**From:** Cammie Dewey <[cdewey@sjrwmd.com](mailto:cdewey@sjrwmd.com)>  
**Sent:** Thursday, February 15, 2024 3:53 PM  
**To:** [Istoever9687@gmail.com](mailto:Istoever9687@gmail.com)  
**Subject:** RE: Stonecrest Meadows par 3 golf course ponds

**From:** [1stoever9687@gmail.com](mailto:1stoever9687@gmail.com)  
**To:** [Rison, Christopher](mailto:Rison, Christopher)  
**Cc:** [Frank Nuite; Maureen Lubas](mailto:Frank Nuite; Maureen Lubas)  
**Subject:** Rezoning Application - Case No. 240211ZP, Sun Golf, LLC, (David Black) - PUD  
**Date:** Wednesday, February 28, 2024 12:37:49 PM  
**Attachments:** [PUD ADM Stonecrest MC FIL.pdf](#)  
[PUD MP Stonecrest MC FL.pdf](#)

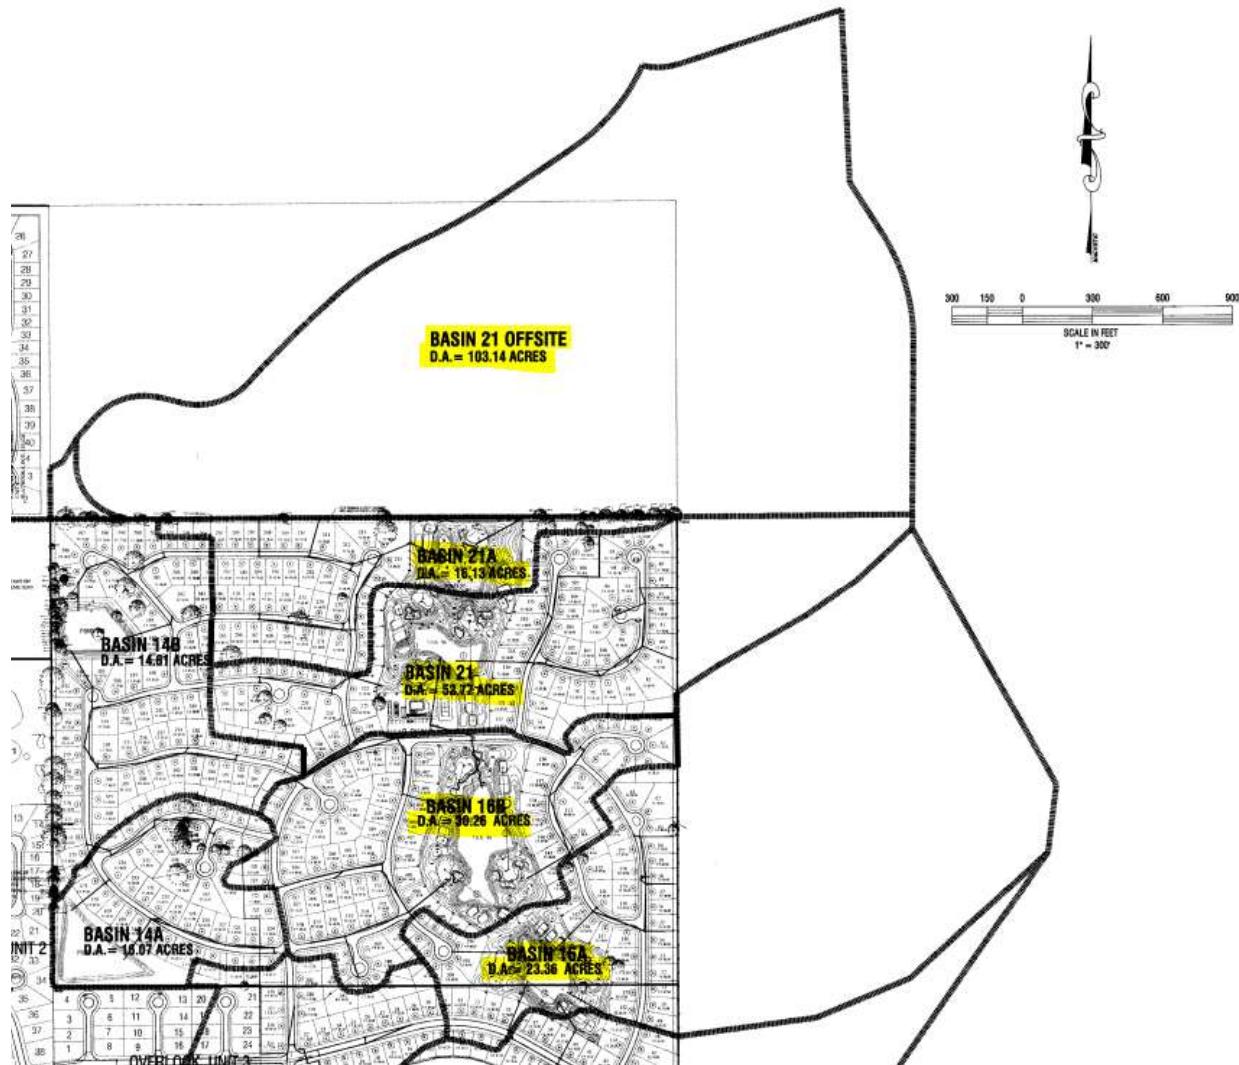
I did quickly review the older permits issued by the District beginning in Dec. 2004 (26719-27, 26719-28, & 26719-30). The golf course area within the Meadows development looks to be noted as pervious area, the golf course area spans across multiple basins (21A, 21, 16B & 16A). I've included a snip of the basin sheet that I found in the sequence 27 permit file that is a bit clearer, the golf course seems to drain towards the four ponds (21A, 21, 16B, & 16A) within the eastern portion of the development and was included in the calculation of runoff for each pond basin.

Based on the calculations that I found in the sequence 27 permit file, the contributing undeveloped off-site area was considered to be pervious and was included in the large storm event runoff volume analysis for ponds 21A and 21.
